COMMITTEE OF THE WHOLE NOVEMBER 18, 2002

**ZONING BY-LAW AMENDMENT FILE Z.02.063
DRAFT PLAN OF SUBDIVISION FILE 19T-02V05
FAIRBROOK DEVELOPMENTS INC.
REPORT #P.2002.59**

DRAFT PLAN OF SUBDIVISION 19T-02V05 FAIRBROOK DEVELOPMENTS INC. LOTS 16 & 17, CONCESSION 4, CITY OF VAUGHAN

CITY OF VAUGHAN REDLINED PLAN NOVEMBER 18, 2002

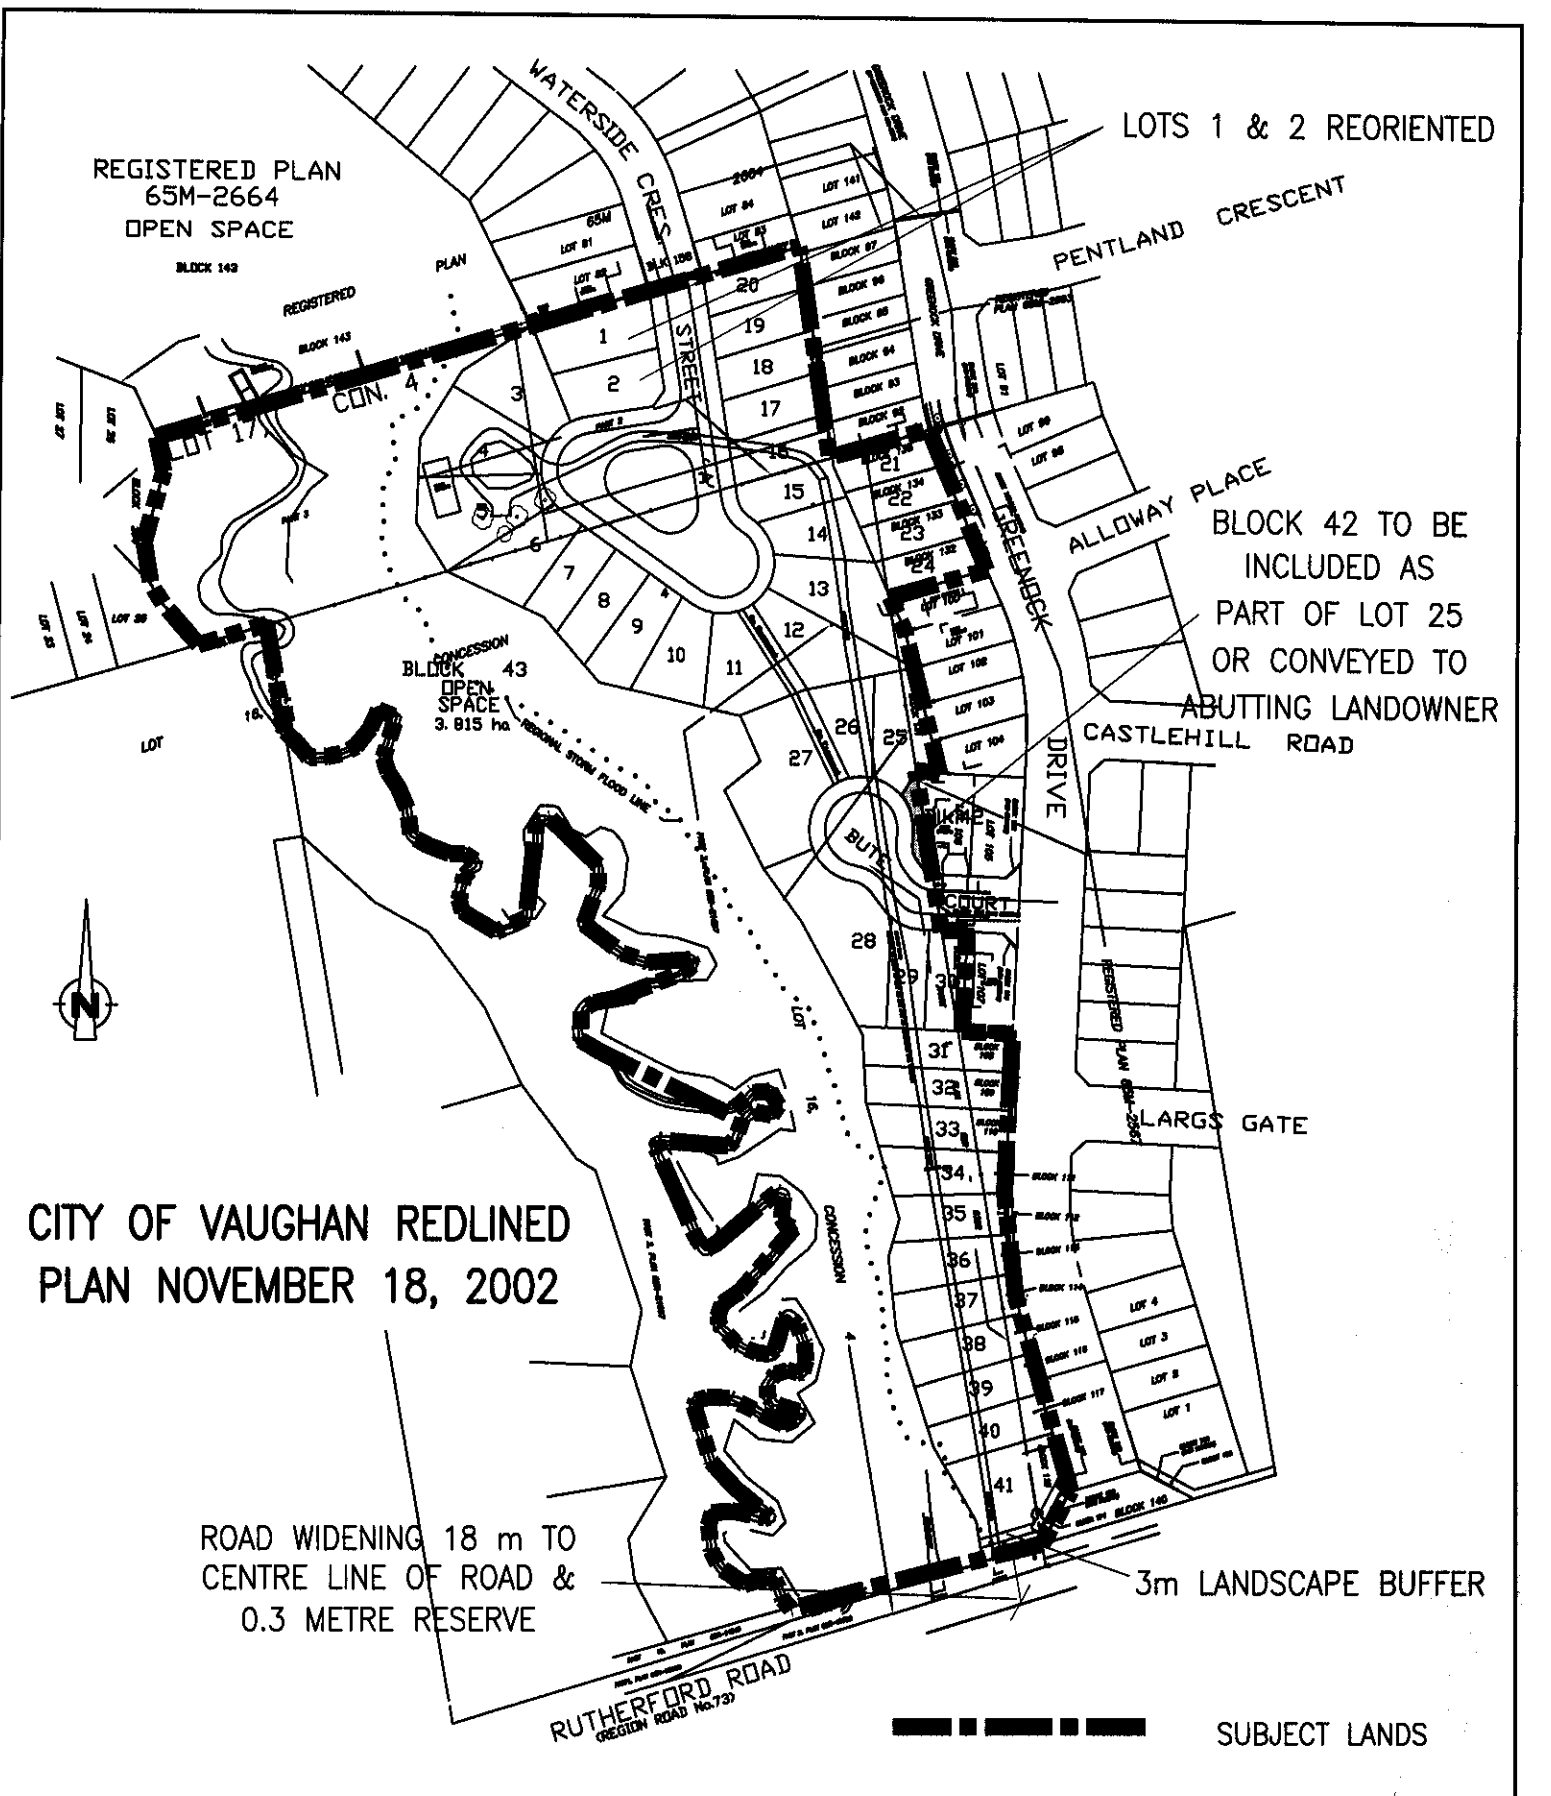
Lots 1 and 2 are proposed to have frontage on the bulb portion of the Waterside Crescent extension. The existing lots to the north have their frontage and homes facing Waterside Crescent. The proposed layout for Lot 1 would create a rear yard and a fence flanking Waterside Crescent, which is inconsistent with the existing pattern of development on Waterside Crescent. Furthermore, the rear yard of Lots 1 and 2 would abut the side yard of the existing dwelling to the north, rather than another side yard. Accordingly, it is recommended that Lots 1 and 2 be reconfigured in an east/west direction, as shown on Attachment No. 3.

The proposed draft plan of subdivision includes a remnant parcel (Block 42), which is not part of any lot and is unacceptable as currently configured. Staff recommends that this block form part of Lot 25, and has red-lined the plan accordingly (Attachment No. 3). Alternatively, the Owner may make suitable arrangements to transfer Block 42 into the ownership of the lands to the east.

In reviewing the suggestion, it has been determined that an entrance feature could be constructed on the subject lands, only on the northwest corner of Rutherford Road and Greenock Drive. A 3m wide buffer strip has been included in the red-line plan, upon which the Owner can include an entrance feature as part of the required landscape master plan.

- a) reorientation of Lots 1 and 2
 - b) the addition Block 42 into Lot 25
 - c) the provision of a road widening to achieve 18m from the center line of Rutherford Road and the associated 0.3m reserve; and

- d) a 3m-landscape buffer along Rutherford Road.
2. The lands within this Plan shall be appropriately zoned by a zoning by-law, which has come into effect in accordance with the provisions of The Planning Act. Particular zoning categories to be applied are as follows:
